**AGENDA  
CITY OF CEDAR FALLS, IOWA  
PLANNING AND ZONING COMMISSION MEETING  
WEDNESDAY, JULY 28, 2021  
5:30 PM AT CITY HALL AND VIA VIDEO CONFERENCE**

**TO:** Planning & Zoning Commission  
**FROM:** Thom Weintraut, AICP, Planner III  
**DATE:** July 22, 2022  
**SUBJECT:** Land Use Map Amendment (LU21-01)  
 Rezoning Thunder Ridge, West 1<sup>st</sup> Street and Eagle Ridge Road (RZ20-009)

**TO:** Planning and Zoning Commission  
**FROM:** Jaydevsinh Atodaria (JD), City Planner I  
**DATE:** July 22, 2021  
**SUBJECT:** Property improvements in the College Hill Neighborhood Overlay District

THUNDER RIDGE REZONING  
PC-2, PLANNED COMMERCIAL  
CITY OF CEDAR FALLS, IOWA  
LANDSCAPING PLAN

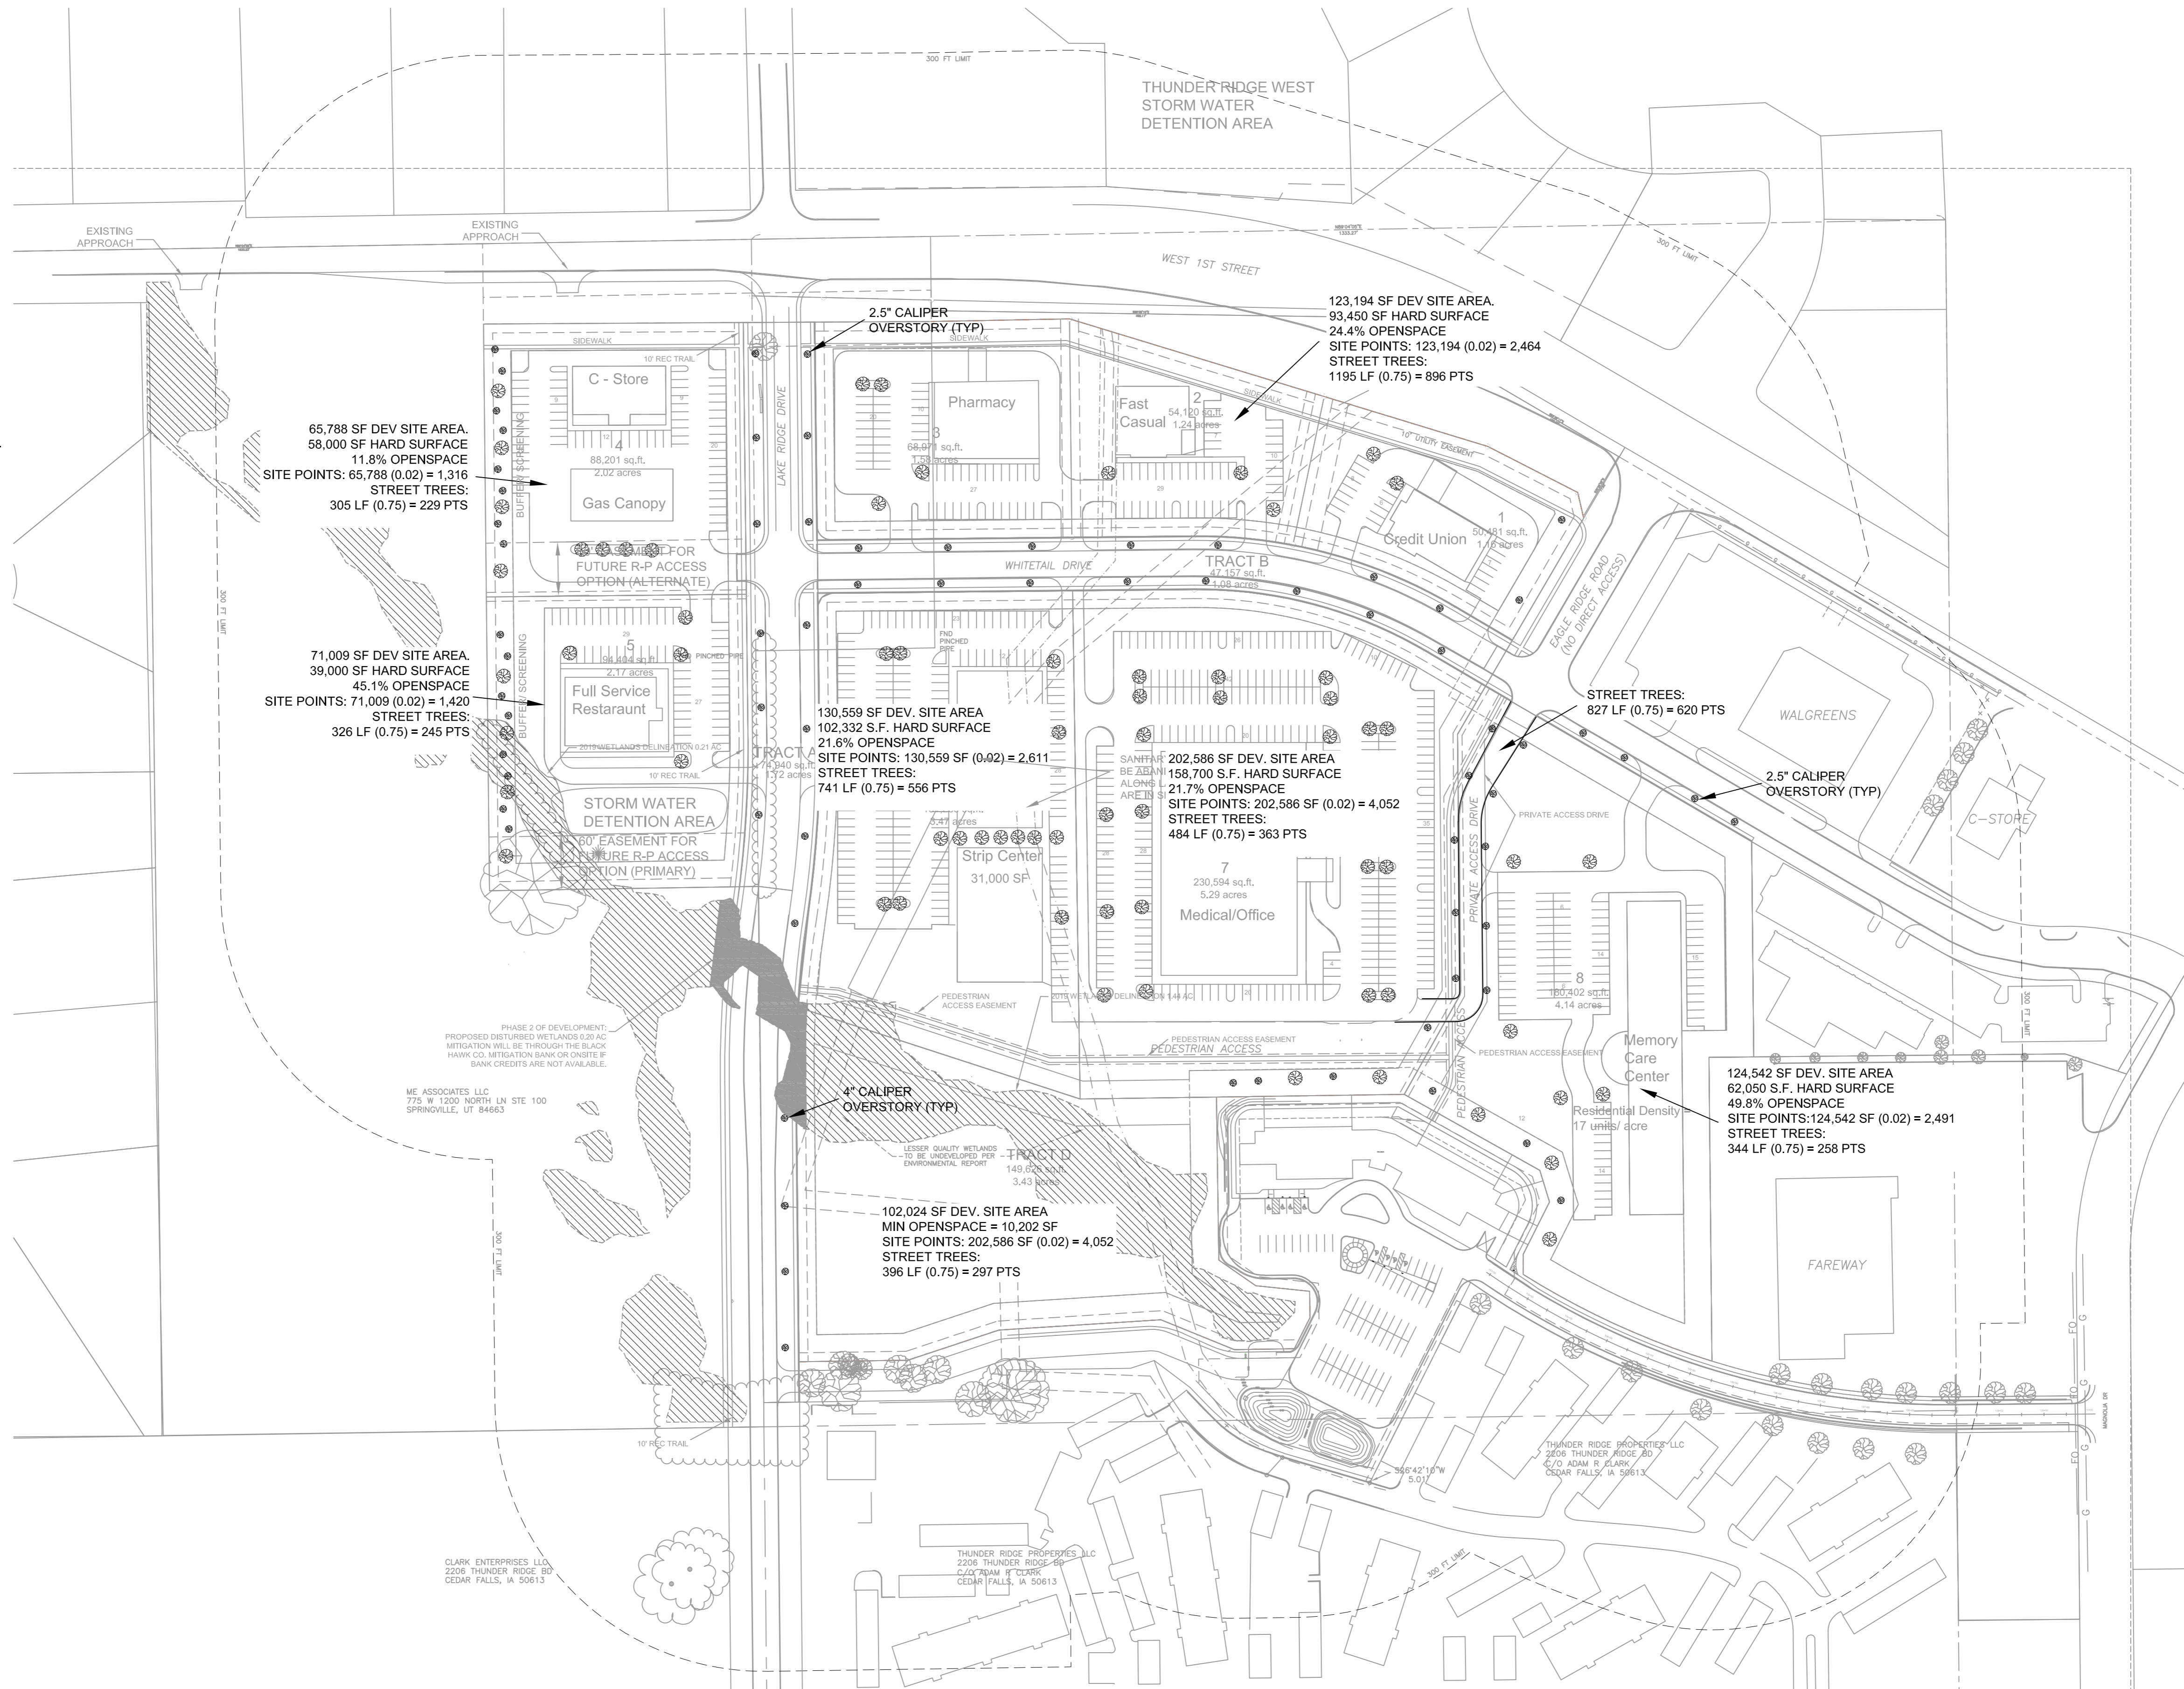
The Land Use, Landscaping and Development Phasing Plan show the buildings between W 1<sup>st</sup> Street and Whitetail Drive focused inward to Whitetail Drive. Staff notes that the architectural renderings provided do not provide details of the appearance of the buildings from the surrounding streets. W 1<sup>st</sup> Street is a “gateway” into the community so thought should be given to the aesthetics of the street views. The applicant has provided a landscape planting palette, which references plants hardy to the local climate.

The Land Use Plan, Development Phasing Plan, Landscape Plan, and Rezoning Plat submitted by the applicant show the majority of the buildings with parking areas between the building and the sidewalks. The siting of buildings is an important aspect in civic design and planning. Buildings should be located close to streets with public sidewalks to provide easy, direct access from public sidewalks to create a convenient, safe, and comfortable environment welcoming to pedestrians. The Thunder Ridge Development Guidelines state that buildings on corner lots will

Since the last Planning and Zoning Commission meeting, the applicant has provided an updated Phasing and Landscape Plan and a updated Rezoning Plat showing sidewalks along W 1<sup>st</sup> Street. They have indicated the Land Use Plan, created by Emergent Architecture, will also be updated to reflect the 1<sup>st</sup> Street sidewalk. Staff also recommends that Emergent update the plan to match the Design Guidelines or simply remove the building and parking lot layouts from the plan to make it clear that the design guidelines must be followed when individual sites are developed. If the submitted master plan and development guidelines conflict, it is unclear how sites should be developed. The documents must be cleaned up to be internally consistent prior to approval.

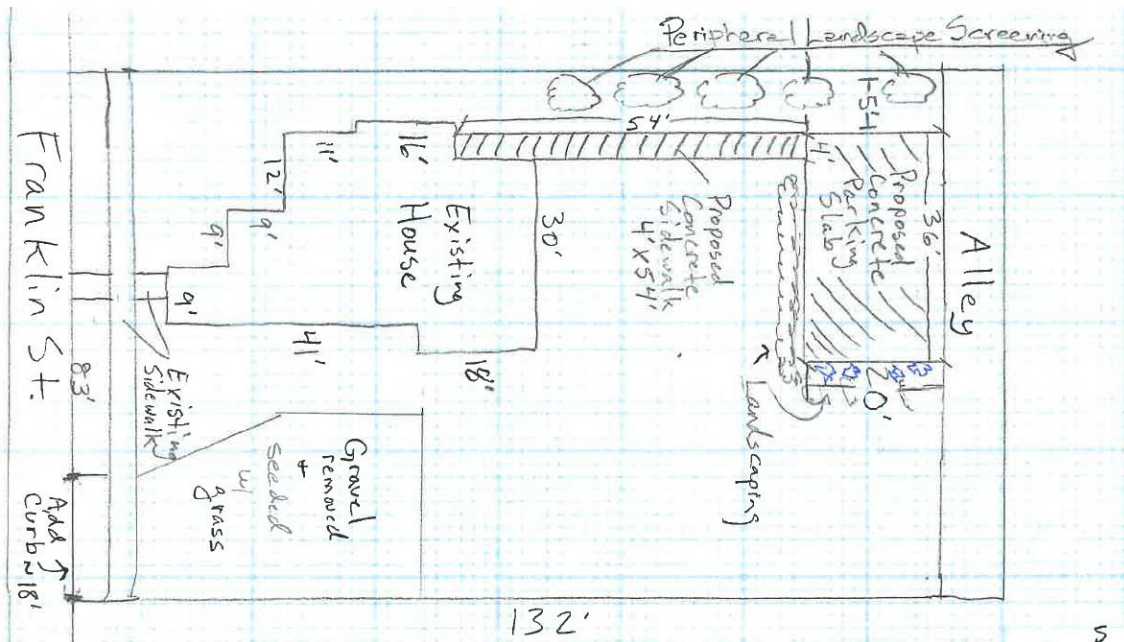
The existing building at 2415 Franklin Street is a two-story structure. No changes to the building envelope are being proposed. Currently, the property has a paved approach and a gravel area for parking on side of the house, which is used for parking. As per Section 11-179, gravel is not allowed and all parking areas or driveways associated with rental properties are required to be hard-surfaced. The applicant plans to remove all the gravel area, replace it with grass and

remove the access point by placing a curb back in Right-of-Way. The applicant in response proposes to pave a parking area/lot behind the house, which will be accessed from the alley, as per suggestions from staff. This was one of the stipulations set forth by the Group Rental Committee while reviewing the "Change in Ownership" application from the applicant. The following is an evaluation of the proposed property improvements according to standards outlined in the College Hill Neighborhood Overlay Zoning District and other applicable codes:

See above sketch for reference. The applicant's proposal reflects the staff's recommendation and the applicant has been very cooperative to make improvements on the property that is best for preserving the character of the neighborhood. The applicant intends to comply with all potential code items that need to be addressed to make this property code compliant. **The proposed site plan intends to preserve the character of the neighborhood.**
